Project	<b>IEEE 802.16 Broadband Wireless Access Working Group</b> < <a href="http://ieee802.org/16">http://ieee802.org/16</a> >	
Title	<b>P802.16h Working Document structure clarification</b>	
Date Submitted	<b>2006-09-17</b>	
Source(s)	Paul Piggin NextWave Broadband Inc. 12670 High Bluff Drive San Diego CA 92130 USA	Voice: 1 858 480 3100 Fax: 1 858 480 3105 <a href="mailto:ppiggin@nextwave.com">ppiggin@nextwave.com</a>
Re:	Working Group Review of Working Document IEEE 802.16h-06/015r1	
Abstract	This document proposes a revised structure of the P802.16h Working Document.	
Purpose		
Notice	This document has been prepared to assist IEEE 802.16. It is offered as a basis for discussion and is not binding on the contributing individual(s) or organization(s). The material in this document is subject to change in form and content after further study. The contributor(s) reserve(s) the right to add, amend or withdraw material contained herein.

# P802.16h Working Document structure clarification

Figure 1: Representation of the suggested Working Document structure.

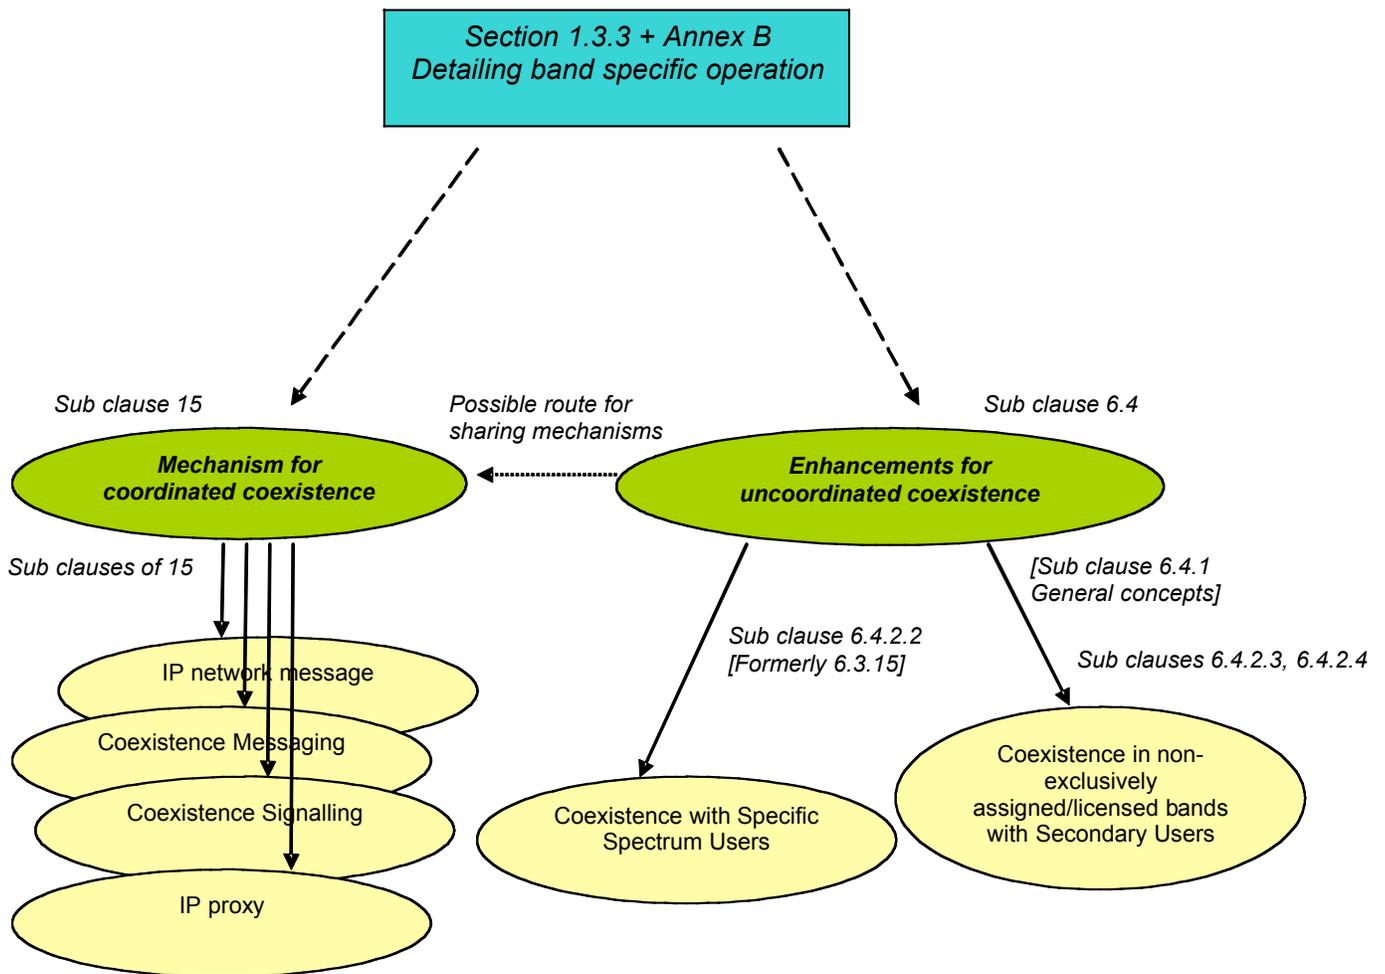
Contributions C802.16h-06/072 [3], C802.16h-06/073 [4], and C802.16h-06/074 [5] at Session #45 suggest additions to the P802.16h Working Document [1] in a number of areas. This contribution considers the overall structure of the resulting document and where these changes are to be applied. It also provides an aid to understanding the wider goals of the group of contributions.

Per the definitions proposed below in this contribution, Clause 15 of [1] provides mechanisms of a coordinated nature. Subclause 6.4 of [1] addresses uncoordinated mechanisms. Contribution C802.16h-06/074 [5] proposes enhancements to those uncoordinated mechanisms. Contribution C802.16h-06/073 provides a summary of the band-specific operational requirements to be added to subclause 1.3.3 and Annex B. C802.16h-06/072 simply provides the definition of additional terms.

**Figure xyz1** Link level representation of DCS operation: (a) interference and remedial action at the BS, (b) interference reporting and remedial action at the MS/SS.

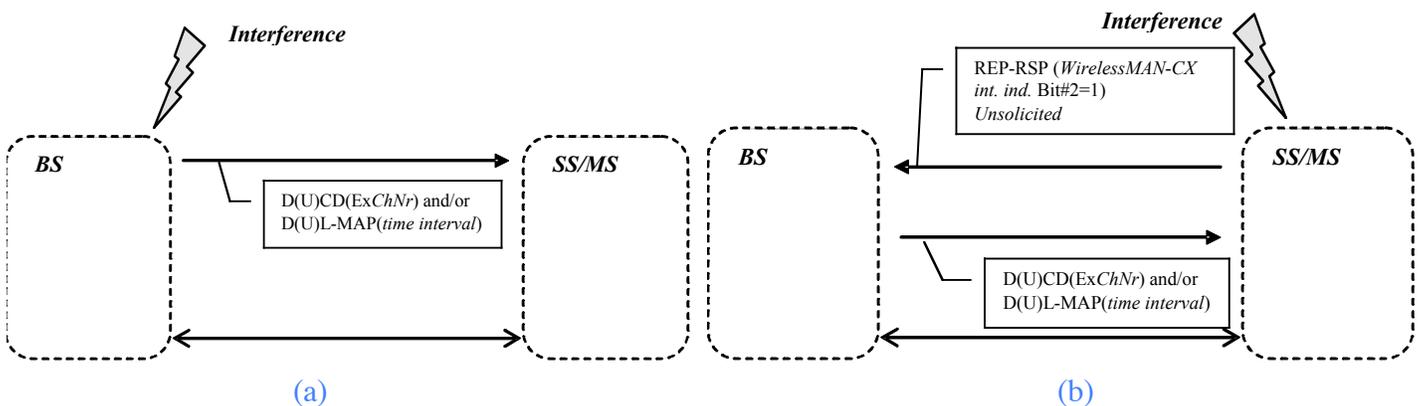
A general example of a DCS solution is provided in figure xyz1 in which interference detection provides agility in frequency and time to reduce the affects of the incident interference.

Dynamic Channel Selection (DCS) is a realization of an *uncoordinated coexistence mechanism* and provides the ability for a system to switch to different *logical channel* based on channel measurements and thus avoiding interference in *non-exclusively assigned* bands. *Logical channels* can be constructed from an operating *frequency* and time component, or a portion thereof. Channel measurement and interference avoidance provide a DCS algorithm with the means of obtaining interference isolation in time and frequency. This approach enables a number of systems to share a given *frequency*. The approach contrasts to that of subclause 6.4.2.2, which specifies SSUs avoidance in which the physical *frequency* is vacated due to the potential interference to the SSU.

Measurement periods are scheduled by the BS via the DL-MAP and the UL-MAP for the BS and SS respectively. Division of the operating frequency into effective time slots provides interference isolation in time and subchannelisation and changes to the operating frequency provides frequency isolation. The divisions in time and frequency, and therefore the creation of *logical channels*, are left to the implementer's discretion.

Mechanisms are supported with the REP-REQ/ REP-RSP (6.3.2.3.33) MAC messages to provide reports of interference and therefore *logical channel* usability. Once a *logical channel* unusable due to prevailing interference that has surpassed a predetermined threshold or degraded the BER sufficiently, the BS may chose to move to a new *logical channel*. This new *logical channel* may be unmeasured or a member of a backup list of available *logical channels* previously measured by the BS. Depending on the prevailing air interface resources, the number of backup *logical channels* may vary. Also the 'freshness' (in terms of when they were measured and how accurate the measurements is likely to be) may depend on available resources to accomplish this task. In the same way the interfered *logical channel* previously vacated may be monitored for usability after some defined period. Figure h1 (subclause 6.4.2.2), although specifically for SSUs, provides an example of how DCS can be used to provide resource management and backup operating channels.
